*Proceedings of the Madras Government, Public Works Department,
28th August 1872.*

No. 488. Read the following letter from the Secretary to the Government of India, Public Works Department (Account—Buildings and Roads), to the Secretary to the Government of Madras, Public Works Department, dated Simla, 1st August 1872, No. 297 A. B. :—

Note on requirements under the head "Military" to be provided from the Department Public Works Grant for Coorg.

Extract from a letter from the Assistant Engineer, Coorg Division, to the Assistant Chief Engineer of Mysore, dated 7th May 1872, No. 113-757.

Fig. II.

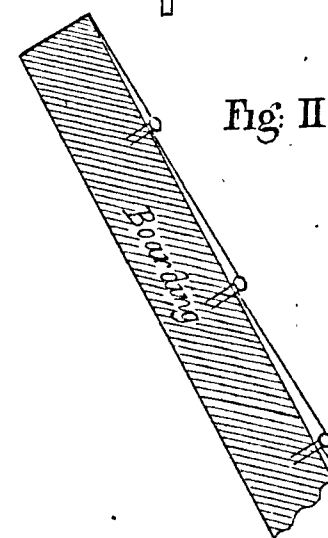
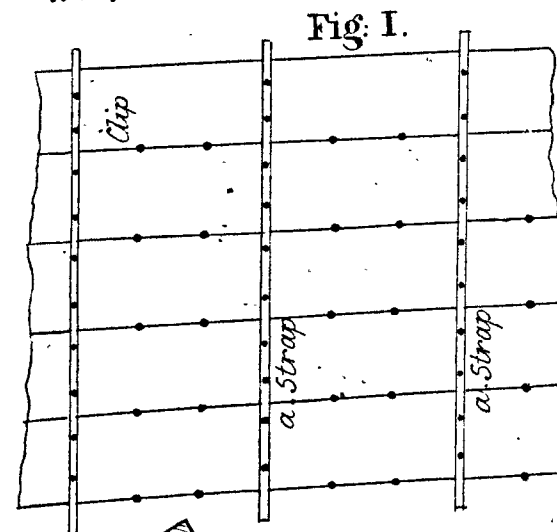
traction of the sheeting occasioned by the variation of temperature, for this purpose the sheeting was held down by straps 5 feet apart, fixed with bolts as shown in annexed sketch Fig. I. At first no other fastenings whatever were fixed between the straps A, but it was found that the high winds blowing during the rainy season lifted up the lower edge of the sheet, and drove the rain below the iron sheeting, on to the boarding, which occasioned considerable leakage on to the ceiling of the upper storey. To remedy this, galvanized clips were inserted between the straps (*vide* Figs. I. and II.), which have lessened the evil but not obviated it, as the roof is still unsound to a great extent. The percolation of water through the roof is of little consequence on the north, west, and south sides of the palace quadrangle, where it falls on a terrace 2½ or 3 feet thick, which is provided with suitable outlets for it, but it makes the east side mess-room and part of the Colonel's quarters, where this terrace has been removed, uninhabitable during the monsoon. To prevent the water passing through the ceiling a layer of concrete 8 inches thick was laid over the ceiling boards, and over it Portland cement about quarter inch thick was plastered. This, I think, would have proved successful, had the concrete been well rammed

and consolidated; but from the spongy appearance it presents now, it is quite evident that this essential part of the work was not done. The layer of Portland cement being exposed to the great heat in the confined space below the roofing showed very soon cracks, which apparently were repaired, but opened again either in the same or in the other places. Through these the water finds its way into the concrete which allows it to percolate into the rooms below. The places in which the ceiling leaked were pointed out to me by the Officer Commanding and the Station Staff Officer, 8th Regiment, Native Infantry, but since then heavy rains having fallen, I had an opportunity of examining them myself. I discovered that the water percolates, not only through the places previously shown to me, which are all situated near the main walls, but also over the whole outer terrace and in several other places in the mess-room and the rooms adjoining it. The provisions made in the estimate forwarded under cover of my No. 61-371 of 1st March 1872 are, therefore, insufficient, and the piping proposed by you (sketch returned) would not meet these new requirements. How these leaks have sprung up since the last monsoon, I am unable to state, but I imagine that Portland cement expands and contracts to a greater extent than concrete, and as the variations of temperature must be considerable below the iron roofing, this may be the cause of the appearance of fresh cracks and consequent leaks.

Fig. III.

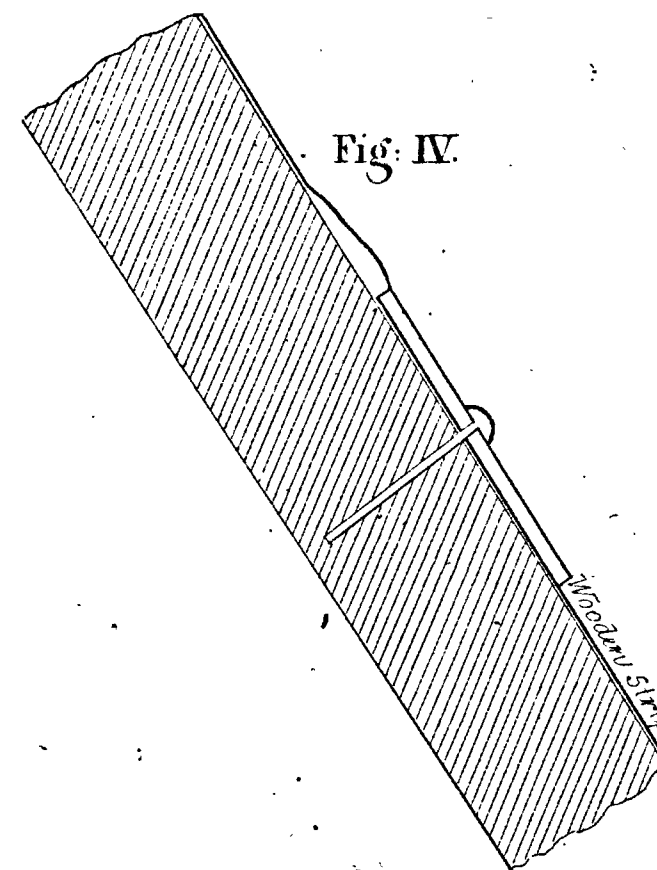
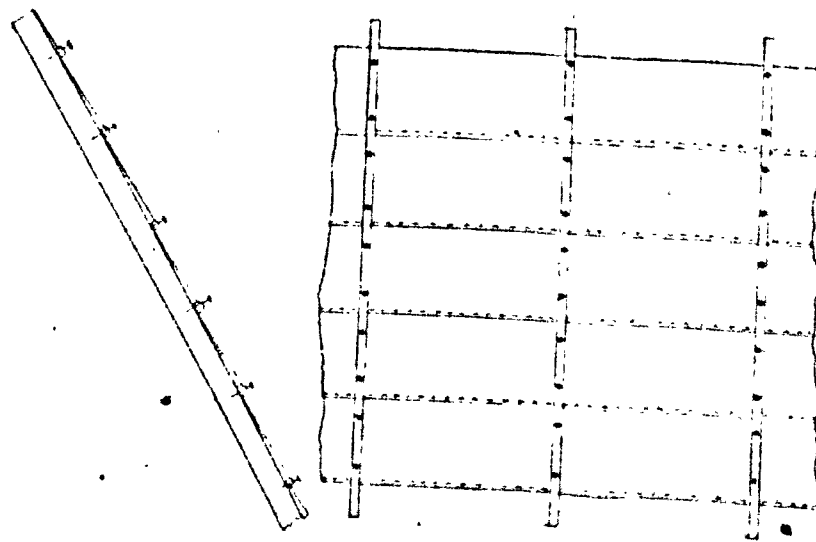
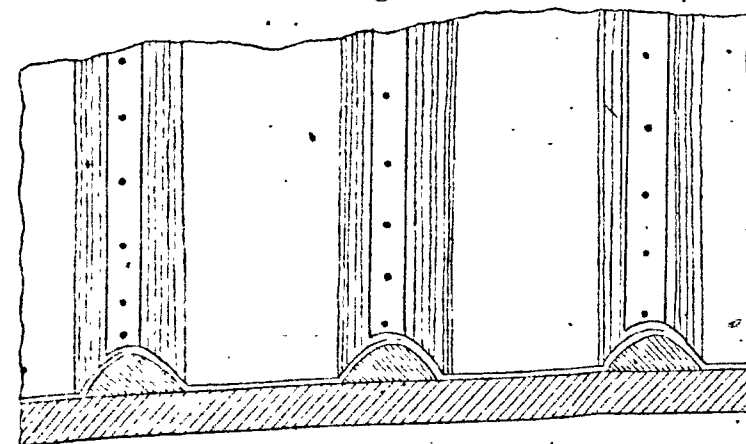
6. Should the above not meet with your approval, I would propose to take the sheeting off the roof and to relay it at right angles to its present position, placing underneath a wooden batten $2\frac{1}{2} \times 1\frac{1}{4}$ " (Fig. V). These pieces will be 1 foot 9 inches, distance from centre to centre. Over them I would bend the continuous sheeting which is 2 feet wide, fastening it the whole length with wire nails 2 inches apart. The roof would form a succession of flat gutters, Fig. VI., and as the nails are driven in the highest portions, the water is thrown off at once, the length of the sheets being only 29 feet will make the expansion about $\frac{1}{8}$ of an inch. I have tried this plan and found it successful, but, in the present case, objections may be raised against it. Moles has been made in the sheeting for the bolts 6, Fig. I., and these would have to be soldered up. In dismantling, no matter how carefully this operation is conducted, some of the sheets are sure to be damaged, and will have to be replaced by new ones. I have no data upon which to base a calculation of the probable cost of this work, but I should say that it will cost certainly not less than 3,000 or 4,000 Rupees.

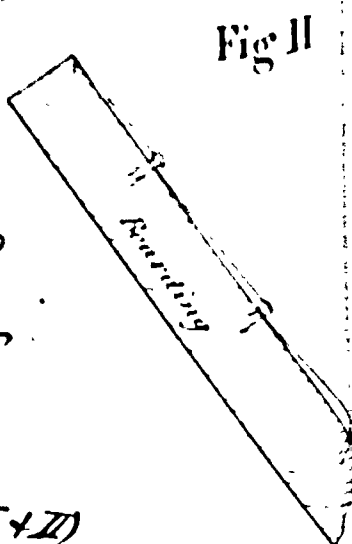
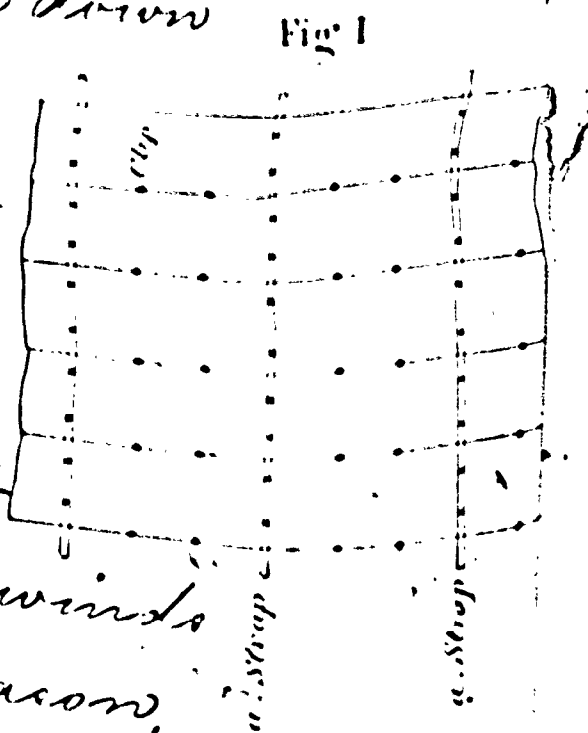
make provision for the expansion and contraction of the sheeting occasioned by the variation of temperature; for this purpose, the sheeting was held down by straps 5-feet-apart, fixed with bolts, as shown in annexed sketch Figure I. At first no other fastenings whatever were fixed between the straps, but it was found that the high winds blowing during the rainy season, lifted up the lower edge of the sheeting, and drove the rain below the Iron sheeting, on to the boarding, which occasioned considerable leakage on to the ceiling of the Upper Storey. To remedy this, galvanized clips were inserted between the straps (vide Figs I & II) which have lessened the evil but not obviated it, as the roof is still unsound to a great extent. The percolation of water through the roof is of little consequence on the north, west, and south side of the Palace Quadrangle, where it falls over a terrace $2\frac{1}{2}$ or 3 feet high

thick, which is provided with suitable outlets for it, but it makes the east side mess room and part of the colonel's quarters, where this terrace has been removed, uninhabitable during the monsoon. To prevent the water passing through the ceiling, a layer of concrete 8 inches thick, was laid over the ceiling boards, and over it Portland Cement about $\frac{1}{4}$ inch thick was plastered. This I think would have proved successful, had the concrete been well rammed, and consolidated; but from the spongy appearance it presents now, it is quite evident that this essential part of the work was not done. The layer of Portland Cement being exposed to the great heat in the confined space below the roofing, showed very soon cracks, which apparently were repaired, but opened again either in the same or in the other places. Through these, the water finds its way into the concrete which allows it to percolate into the

rooms below. The places in which the ceiling leaked were pointed out to me, by the Officer Commanding and the Station Staff officers 8th Regiment A. S. but since then, heavy rains having fallen, I had an opportunity of examining them myself. I discovered that the water percolates not only through the places previously shown to me, which are all situated near the main walls, but also over the whole outer terrace, and in several other places in the Mess Room and the rooms adjoining it. The provisions made in the estimate forwarded under cover of my No. $\frac{61}{37}$ of 1st March 1872 are therefore insufficient and the repairs proposed by you (sketch returned) would not meet these new requirements. Since these leaks have sprung up since the last monsoon, I am unable to state, but I imagine that Portland Cement expands and contracts to a greater extent than concrete, and as the variation of temperature must be considerable below

Fig V

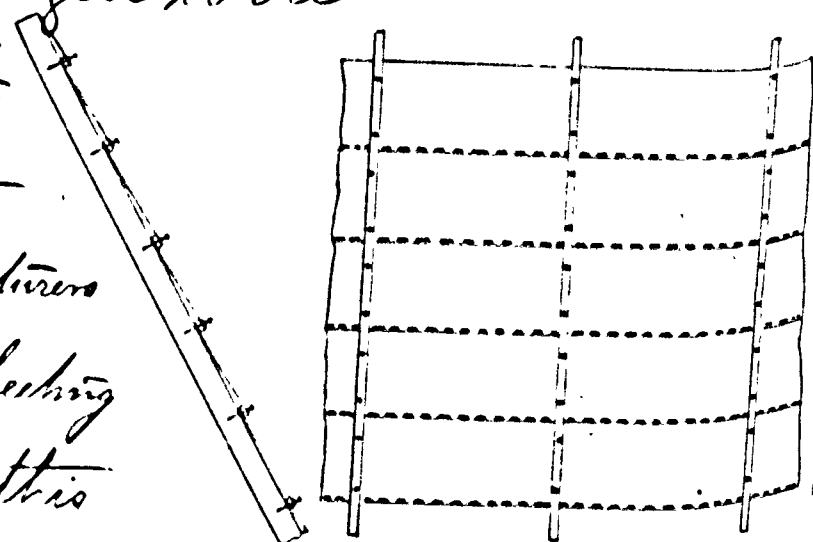
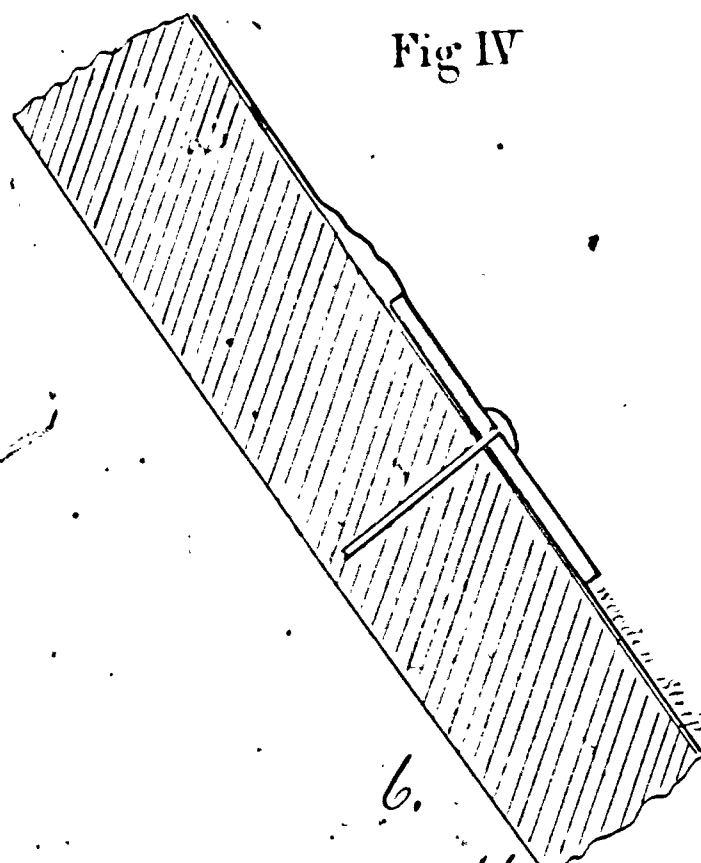
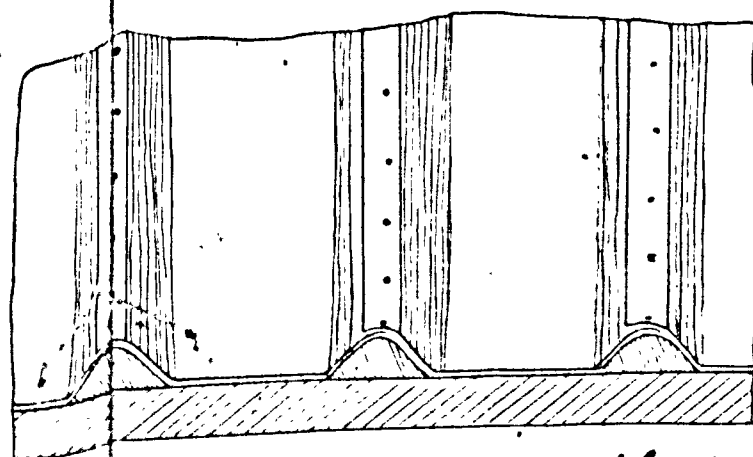
Should the above not meet with your approval, I would propose to take the sheeting off the roof and to relay it at right angles to its present position, placing under each lap a wooden batten $2\frac{1}{2} \times 1\frac{1}{4}$ (Fig V).

These pieces will be 1-7" distance from centre to centre. Over them I would bend the continuous sheeting which is 2 feet wide, fastening it the whole length with wire nails 2" apart. The roof would form a succession of flat gutters, Fig VI, and as the nails are driven in the highest portions, the water is thrown off at once, the length of the sheets being only

29 feet, will make the expansion about $\frac{1}{8}$ of inch. I have tried this plan and found it successful, but in the present case, objections may be raised against it. Holes have been made in the sheeting for the bolts, Fig I, and these would have to be soldered up. In dismantling, no matter how carefully this operation is conducted, some of the sheets are sure to be damaged, and will have to be replaced by new ones. I have no data upon which to base a calculation of the probable cost of this work, but I should say that it will cost certainly not less than 3 or 4,000 Rupees.
